SERVICE BULLETIN

COMMUNICATIONS
75S-3B RECEIVER, CPN 522-3316-000
75S-3C RECEIVER, CPN 522-3317-000
SERVICE BULLETIN NO. 2

SECOND MIXER PLATE CIRCUIT IMPROVEMENT

Chassis Component Location, Bottom View
Figure 1

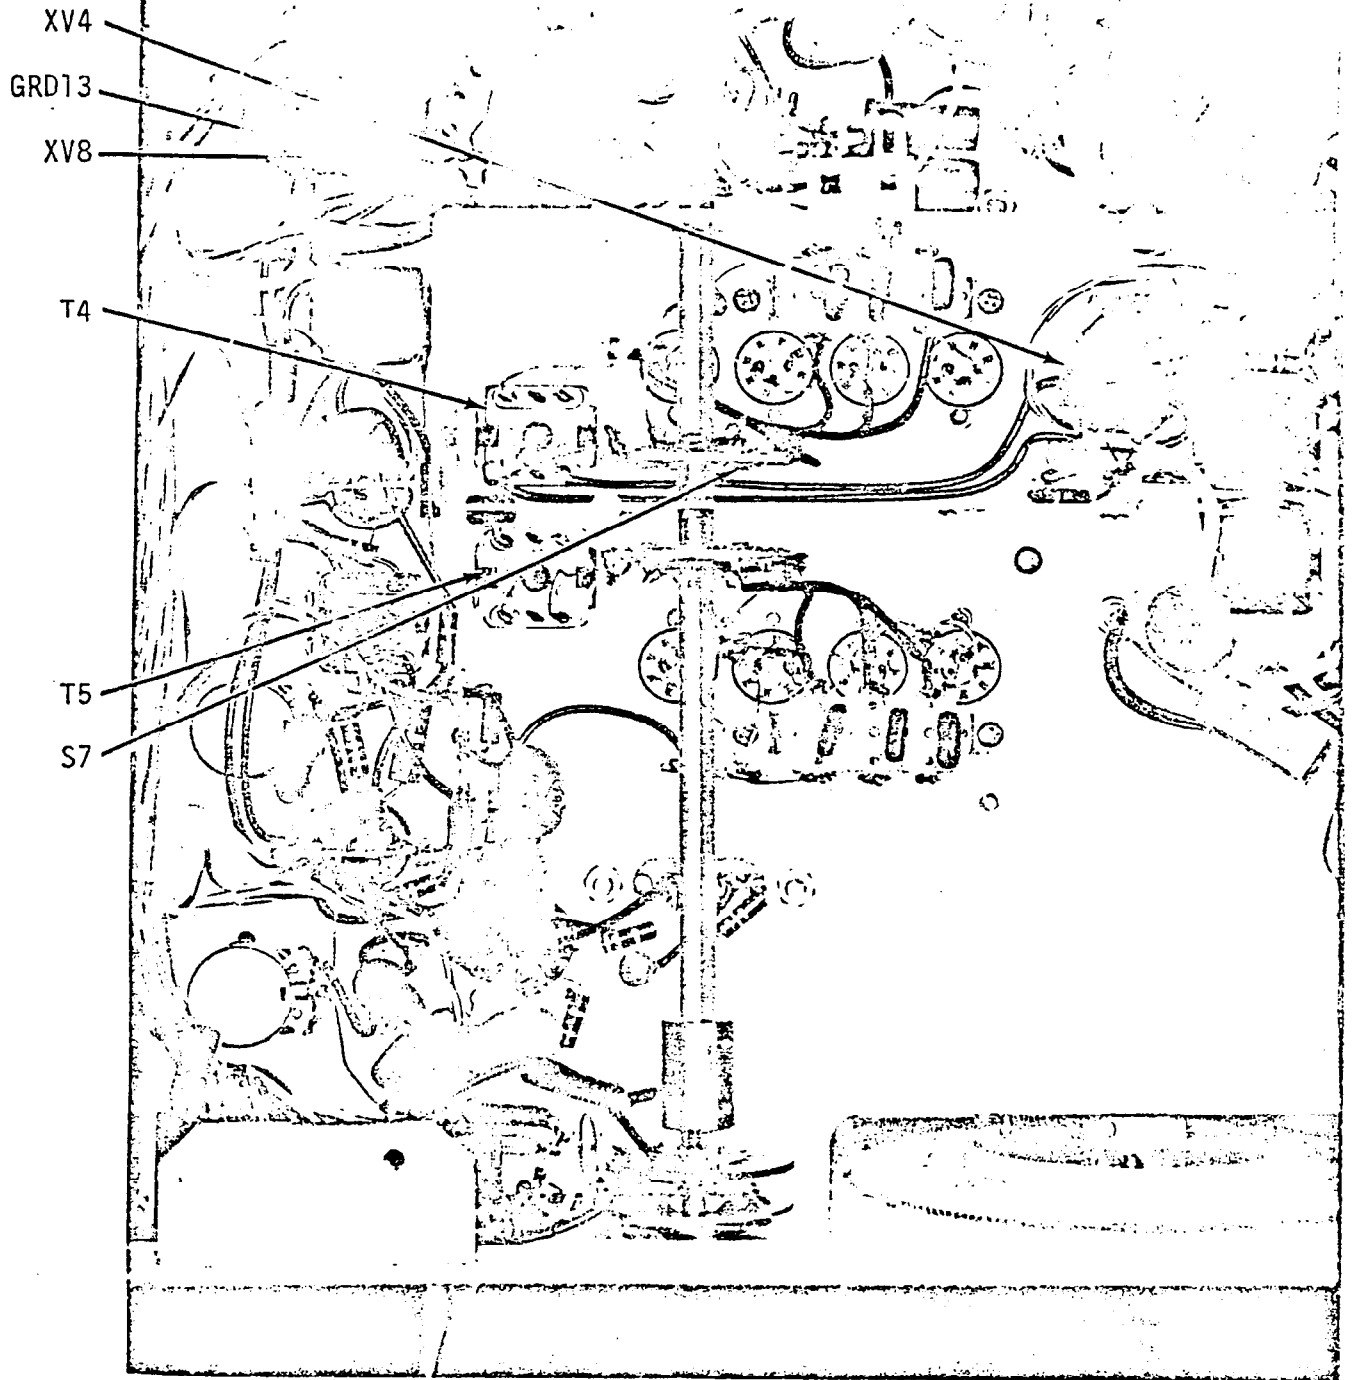
- (1) Remove four feet and the screw located midway between rear feet from bottom of cabinet.
- (2) Remove the unpainted screws located under lid along front of cabinet.
- (3) Slide chassis from the cabinet.
- (4) Referring to figure 1 for location, remove cover over T4 and XV4. Retain cover and attaching hardware.
- (5) Referring to figure 1 for locations, remove and discard the following components and wires from their respective connections:

<u>DESCRIPTION</u>	<u>FROM</u>	<u>TO</u>
15K resistor, R89	S7-10	Ground
0.001-uf capacitor, C32	S7-10	XV4-6
3-pf capacitor, C92	T4-3	T5-3
10-mh choke, L4	XV4-1	XV4-6
100-uh choke, L16	XV8-8	Ground
Bus wire	T4-4	T4-2
Bus wire	T4-1	S7-5

Chassis Component Location, Bottom View
Figure 2

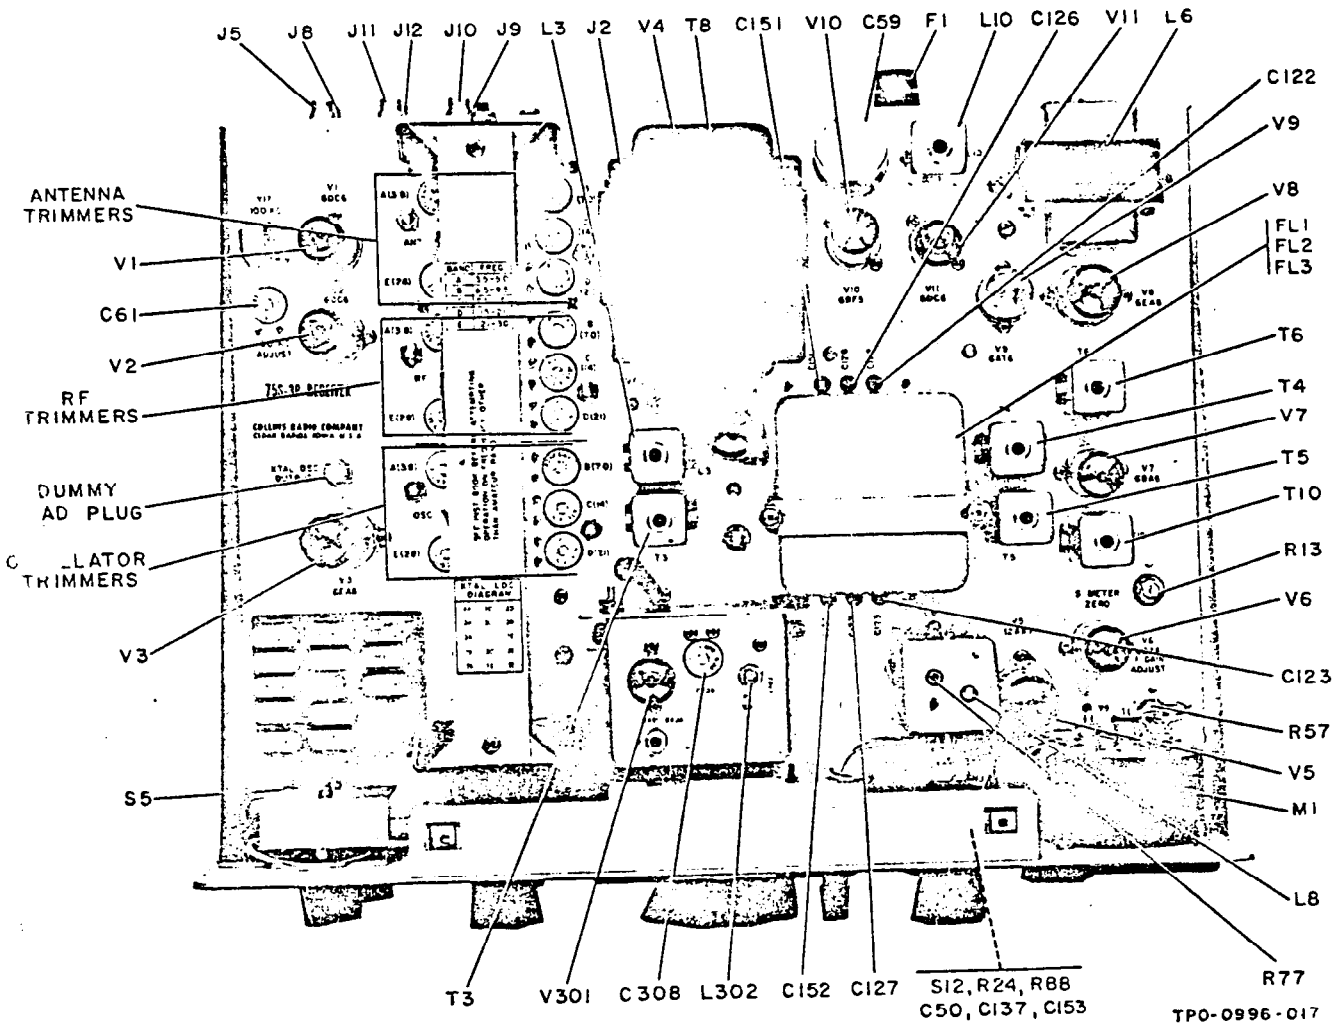
- (6) Referring to figure 2 for locations, install the following components and wires to their respective connections:

<u>COLLINS PART NO.</u>	<u>DESCRIPTION</u>	<u>FROM</u>	<u>TO</u>
422-4312-000	Wire, #22 AWG bus, Teflon	XV4-3	T4-2
422-4312-000	Wire, #22 AWG bus, Teflon	XV4-6	T4-1
916-0122-000	6-pf capacitor, C92	T5-3	S7-5
916-0122-000	6-pf capacitor, C32	T4-3	S7-10 (common)
240-2141-000	100-uh choke, L16	XV8-8	Ground

75S-3B/3C Location of Adjustments
Figure 3

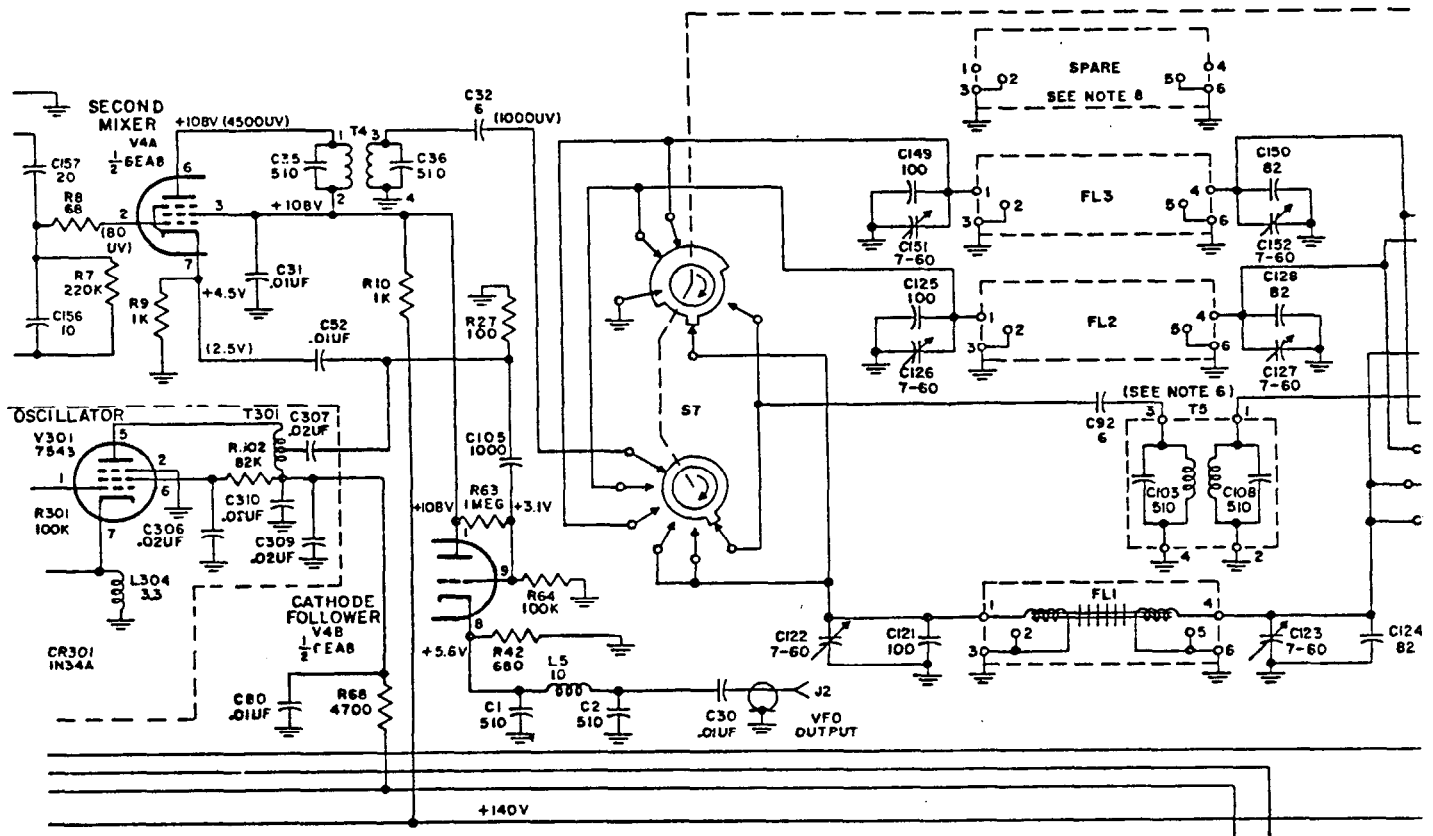
- (1) Referring to figure 3 for tuning adjustment locations, perform the following alignment steps using the crystal calibrator as a signal source and the S-meter as a peak indicator:

- (a) Position MODE switch to LSB and FUNCTION switch to CAL. Tune receiver to center of bandpass near 100 on the dial (approximately 1.5 kHz tone) and adjust PRESELECTOR for an S-5 reading on the S-meter.
 - (b) Using Walsco 2543 hex-tuning wrench or equivalent, peak the two slugs in T4. Both slugs can be peaked from the top of the unit.
 - (c) Peak capacitor C122 with a small flat-blade screwdriver.
 - (d) Repeat peaking T4 slugs.
- (2) Replace cover removed in step (4), and replace chassis to cabinet removed in paragraph 2.A. step (1).
